SEPTEMBER 25, 2017

COA 17-64

714 Georgia Avenue

Installation of an aluminum
 fence.

Proposed Fence

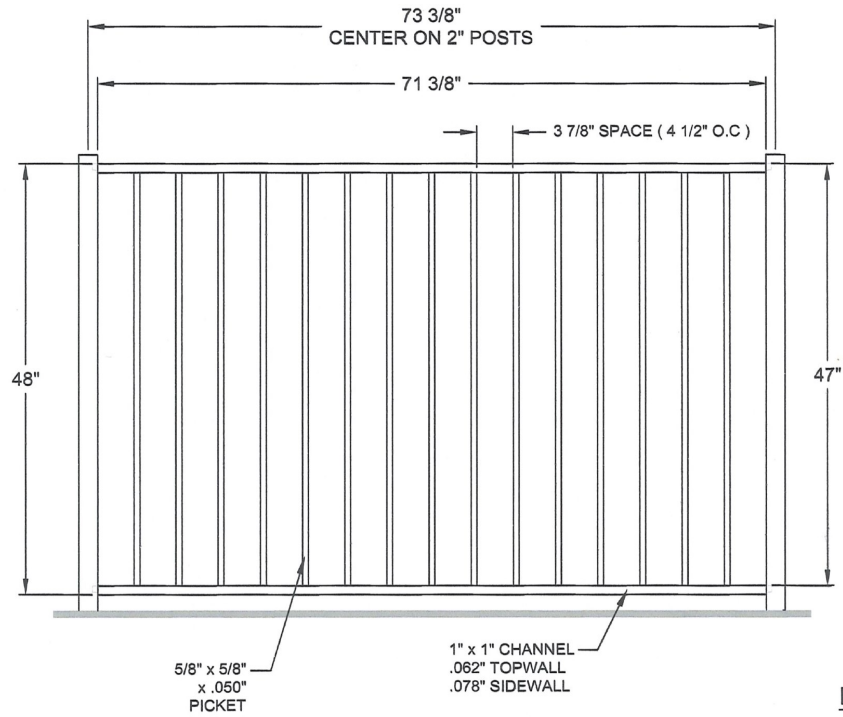
The current proposal seeks to install a 4 foot high, aluminum fence that is incompatible with character and architecture of the surrounding properties and their environment.

Staff recommends that the Board deny the request as submitted based upon Secretary of Interior Standard 9.
